**RE: SE-4694 WORD POWER BAPTIST  
TABERNACLE**

**Special Exception**  
**Alternative Compliance**  
**Word Power Baptist Tabernacle**

**SE-4694**  
**AC-20017**

**TECHNICAL STAFF REPORT:**

Special Exception Site Plan Scale 1"=200'

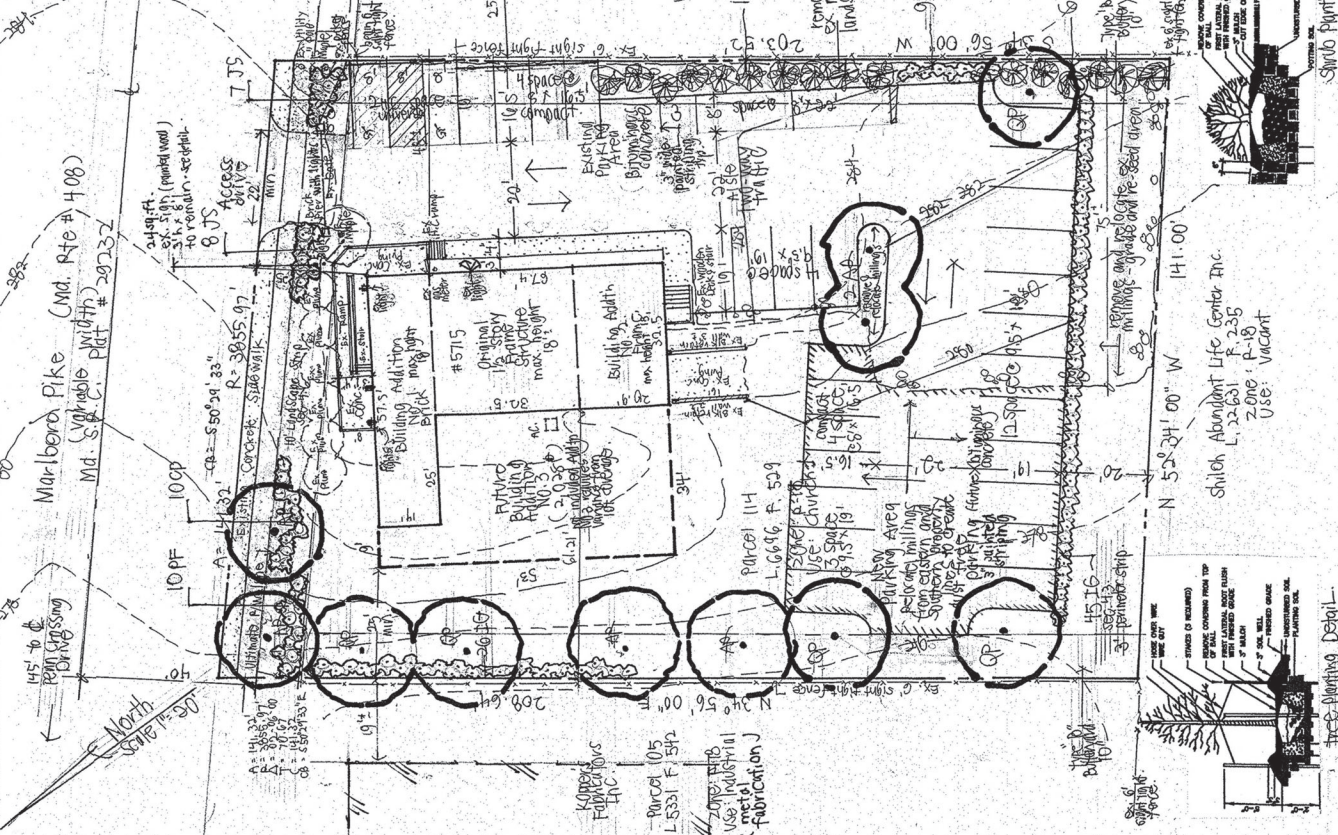
The site plan requires revisions to show a 60 percent maximum allowable lot coverage for the site. The plans currently reflect a maximum requirement of 50 percent lot coverage; however, that requirement is applicable to churches on lots between 1 and 2 acres. The site plan should also be revised to show a proposed lot coverage calculation, which includes the future building addition, if proposed and approved with this application.

**Section 4.3-2, Interior Parking Lot Landscape Requirements**—The Section 4.3-2 landscape schedule indicates the interior parking lot planting area proposed is 979 square feet, which would require a total of four shade trees be provided (one per 300 square feet or fraction thereof the total area). The schedule indicates three shade trees are required and three are provided. The landscape plan and schedule require revision to meet the minimum requirement.

**South:** The southern abutting property is vacant, but zoned R-18. A Type 'B' Landscape Bufferyard, including a 20-foot-wide landscape yard with 80 plants per 100 linear feet of property line and a minimum building setback of 30 feet, is required. A 20-foot-wide landscaped yard area is available along the southern property line; however, the applicant needs to provide a Schedule 4.7-1 on the site plan, to demonstrate compliance with Section 4.7. As previously mentioned, the

applicant will need to remove Schedule 4.3-1 from the site plan and provide a new Schedule 4.7-1 with the corresponding required landscaping for the southern property line. It is noted that bufferyard requirements may be reduced up to 50 percent if a 6-foot-high, opaque fence is provided, give the abutting residential zoned land is vacant (pages 90–91, Landscape Manual).

1. Prior to certification of the special exception, the following revisions shall be made to the site and landscape plan:
  - a. Provide a Schedule 4.7-1 on the site plan showing a Type 'B' Landscape Bufferyard, in accordance with Section 4.7 of the 2010 *Prince George's County Landscape Manual*, along the southern property line (vacant residential site).
  - b. Update the site plan to show a 60 percent maximum allowable lot coverage for the site.
  - c. Label the number of stories of the building and clarify the gross floor area, for the 1925 building and each addition.
  - d. Regarding the future building addition shown on the plans, clarify if the addition is proposed at this time or remove the addition from the plans. If the addition is proposed at this time, provide the following:

- (2) Clarify the proposed square footage and number of stories.
  - (3) Building-mounted lighting shall be shown on architectural elevations.
  - (4) Revise the proposed lot coverage calculation to account for the building expansion and update the total proposed square footage in the general notes.

- e. Update the landscape schedule to clearly identify each species as native or nonnative.
  - f. Revise the proposed landscaping and landscape schedule for compliance with Section 4.3-2 of the 2010 *Prince George's County Landscape Manual*, demonstrating a minimum of one shade tree for each 300 square feet of interior planting area and fraction thereof is required and provided.
